**Draft proposal for amendments to Regulation No. 43
(safety glazing)**

This document was prepared by the informal group on the introduction of plastic glazing for windscreens and laminated plastic panes other than windscreens in Regulation No. 43 (IGPG). It supersedes the informal document GRSG-104-43. The modifications to the current text of the Regulation are marked in bold or strikethrough characters.

Figure 6 sand drop equipment

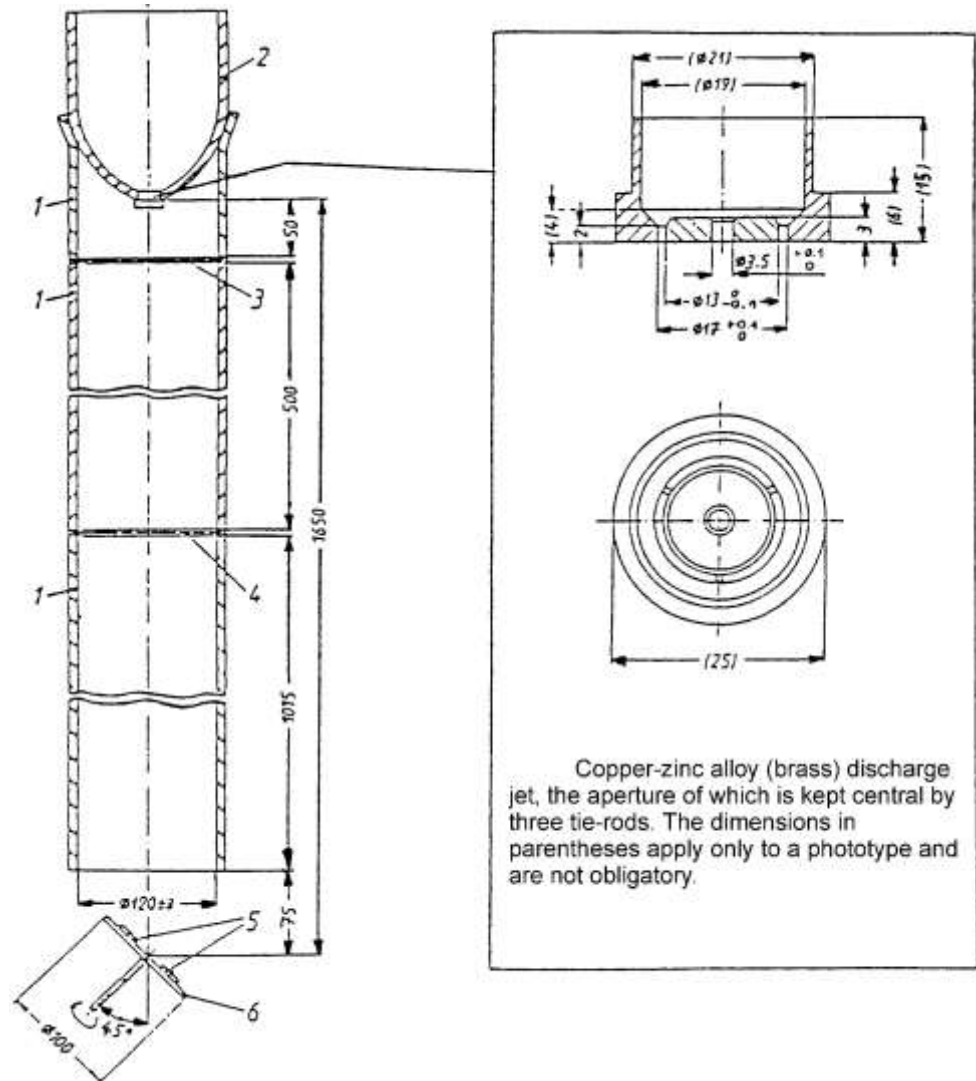
Insert a new paragraph 4.7. and a new Figure 6, to read:

“4.7. Sand Drop Test

The sand drop test equipment consists essentially of that illustrated in Figure XX. The gravity tube consists of three separate rigid polyvinylchloride tubes (PVC hard) of the same diameter, with two polyamide sieves mounted in between. The sieves should have a mesh size of 1.6 mm. The speed of the turntable shall be 250 ± 10 rpm.

Figure 7 - Movement pattern of washing brush and nozzle

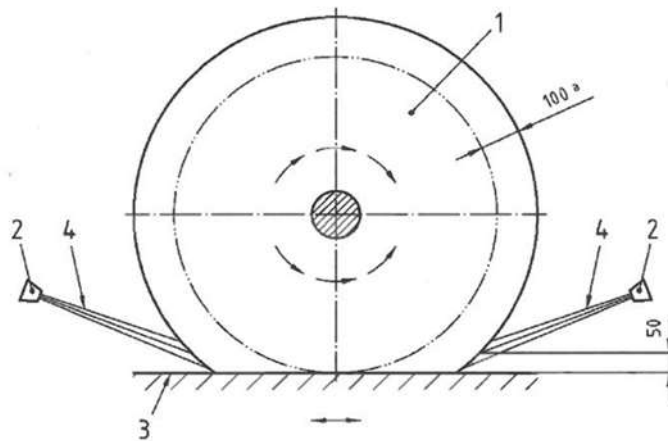
“4.8. Car Wash Test

diameter	(1 000 ± 40) mm
width	Minimum 300 mm
rotation speed	(127 ± 5) min ⁻¹
brush rotation	rotates in the opposite direction relative to the direction of travel of the test panel holder
material	polyethylene
bristle profile	x-shaped, spliced
bristle thickness	(0.8 ± 0.2) mm
bristle length	(440 ± 20) mm visible
penetration depth	(100 ± 20) mm (see figure XXX)

feed speed	(5 ± 0.2) m/min
pattern of movement	if the brush is rotating clockwise, the right nozzle is spraying and the test panel holder travels from the left side to the right side (and vice versa)

Figure 8 – calibration arrangement

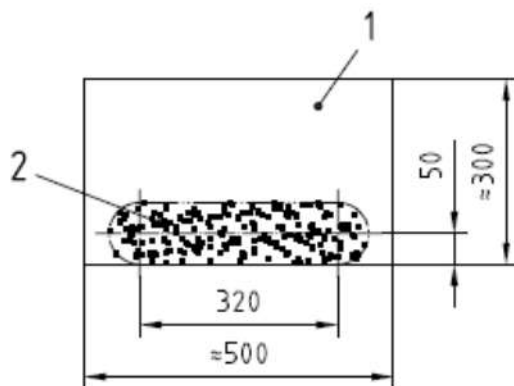
Do the instrument calibration as follows: Set up the equipment as shown in Figure 8. Fill with washing suspension (see paragraph 4.8.2. of this annex and wet the brush sufficiently. Determine the flow rate of the water, (2.2 ± 0.1) l/min, by measurement and adjust by altering the pressure, (300 ± 50) kPa. Check the spray pattern of the nozzles (see Figure 9) If the spray pattern cannot be achieved or if the pressure regulation exceeds the tolerances, check, and if necessary replace, the nozzles.

Figure 10: Description of sample positioning on the test holder

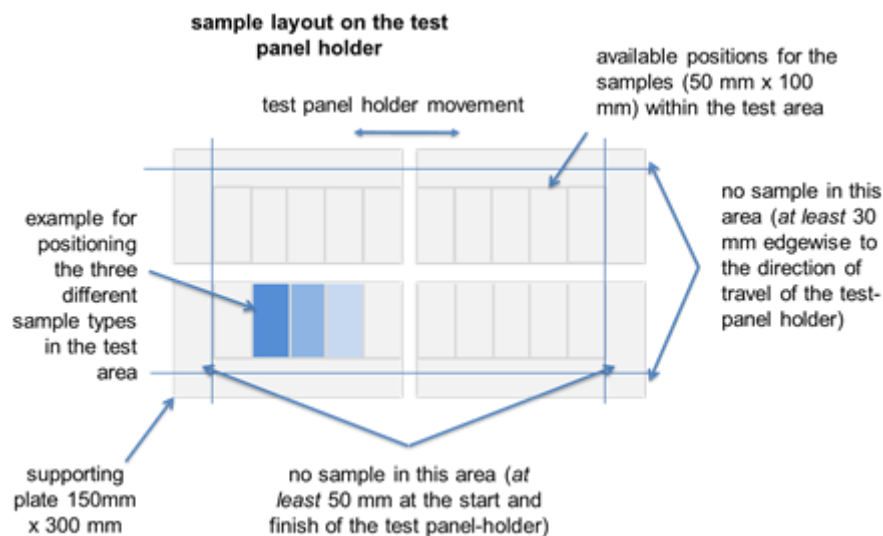
- 4.8.4.2.1. Affix the samples with the outside surface face up onto a supporting plate by using a double-faced adhesive tape (Sample positioning on the test holder as shown in Figure 10).
